2029 24TH AVE S
#3025443 Administrative Design Review 02.28.2019

1. Massing/Materials

2A. Lobby and Amenity Space moved to street corner

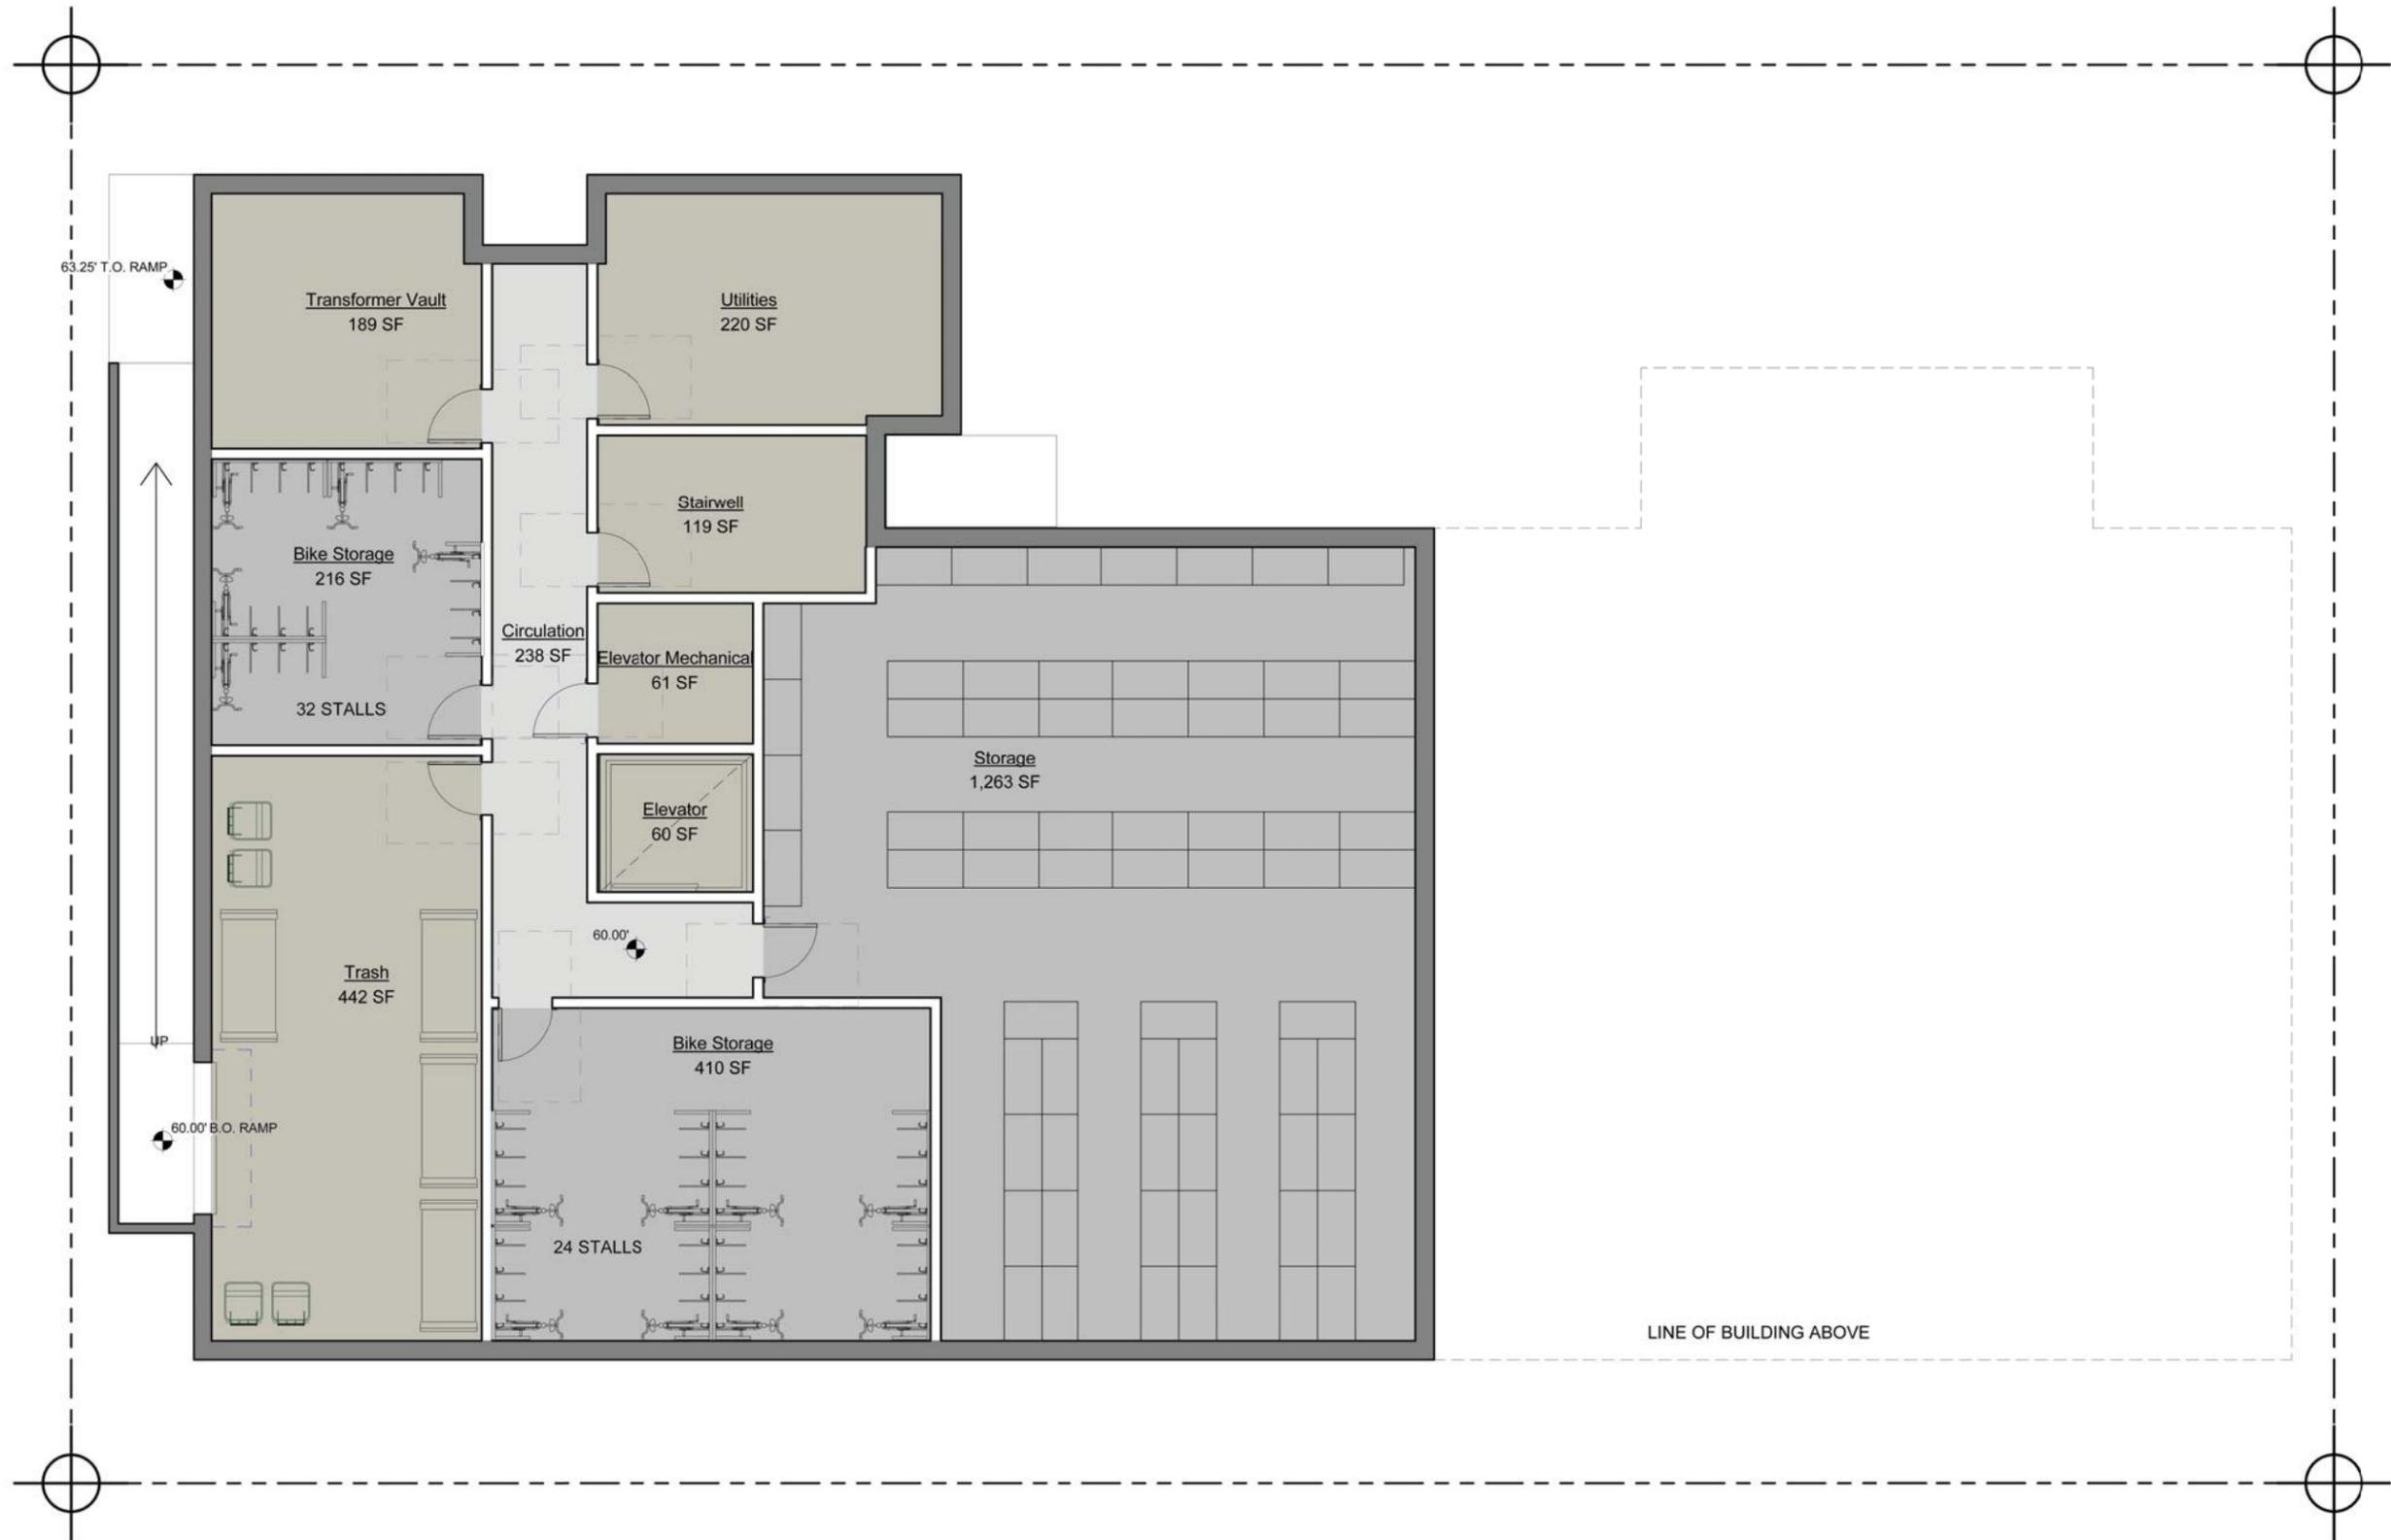
A The Board had concerns about the location of the lobby and common room shown on the preferred Option C. The Board felt that the lobby needs to better respond to the pedestrian environment and existing built environment by creating an inviting entry space. The Board recommended relocating the lobby and/or community room to the east side of the building, at the corner of 24th Avenue and Hill Street. The Board thought that situating one or both common areas in these locations is an appropriate response to create the pedestrian level of engagement appropriate at the street level at the intersection. (PL3-B, PL2-B, CS2-B)

B The Board felt that if ground level units on the east side of the building were to remain, then the entry to those units should be located off 24th Avenue to engage the street. The Board also felt enhanced landscaping and glazing at the ground level was appropriate along the east facing façade. (CS2-B)

The lobby and ground related amenity space has been relocated to the south east corner of the site (on the corner of S Hill St. and 24th Ave S.). Additionally, the ground related amenity has been consolidated and will include a television area, kitchen facilities, dining room table, and direct access to the courtyard and north patio space.

The units located along 24th Ave S on the ground level have been removed due to the relocation of the lobby and amenity space. These units have been relocated to the center of the building on the ground floor with three units facing the north courtyard and 5 units facing S Hill St. with Juliet balconies. Additionally, glazing has increased at the ground level along 24th Ave S.

EAST ELEVATION - VIEW OF SITE FROM 24TH AVE S.

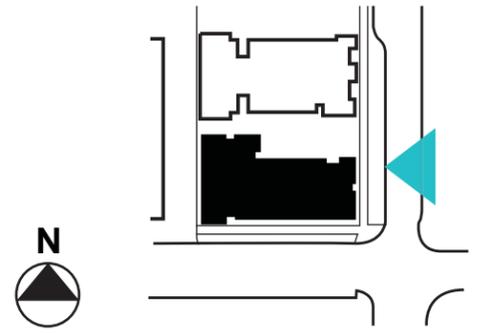
C The Board had concerns about the lack of glazing and visual interest on the east facing façade shown for floors 2-4. The Board again felt that increased glazing, added architectural elements or possibly reorienting the upper level units should be included to these upper floors for this façade to create visual interest and compliment the building to the immediate north (MUP #3020618). (DC2-B)

Glazing area along 24th Ave S has increased with the addition of horizontal awning windows and larger floor to ceiling windows located in the corridors.

2C. Increased glazing on upper floors

NORTH / SOUTH BUILDING SECTION THROUGH COURTYARD

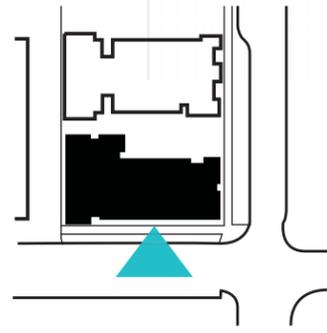
B The Board requested a cross-section of the courtyard space and its relationship between this building and the proposed building to the north (MUP #3020618). (DC2-C)

The cross section provided shows the courtyard space and the relationship between the proposed building and the building to the north.

NORTH/ SOUTH BUILDING SECTION THROUGH UNITS

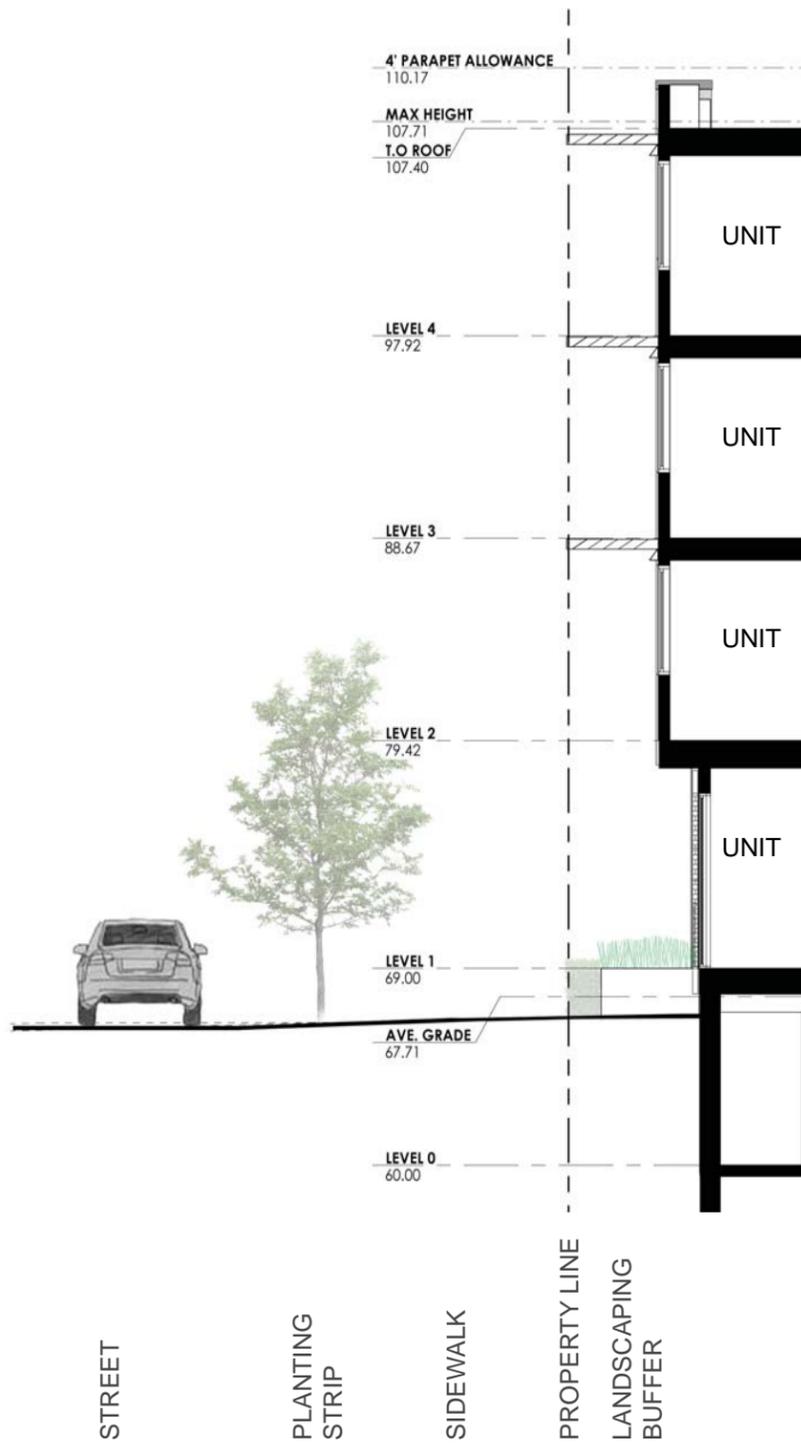
The floor of a Dwelling Unit located along the street level, street facing facade, shall be at least 4' above or 4' below sidewalk grade or be setback at least 10' from the sidewalk.

Allow for street level floor of Dwelling Units facing S Hill St to be located approximately 1.36 feet above the average sidewalk grade with a Setback of 6.5 feet.

A prominent entrance is created at the corner of S. Hill St and 24 Ave S. that has an accessible route to the Dwelling Units at the associated floor. The ground level treatment of the Structure is buffered by landscaping and planters from the sidewalk to minimize the impact.
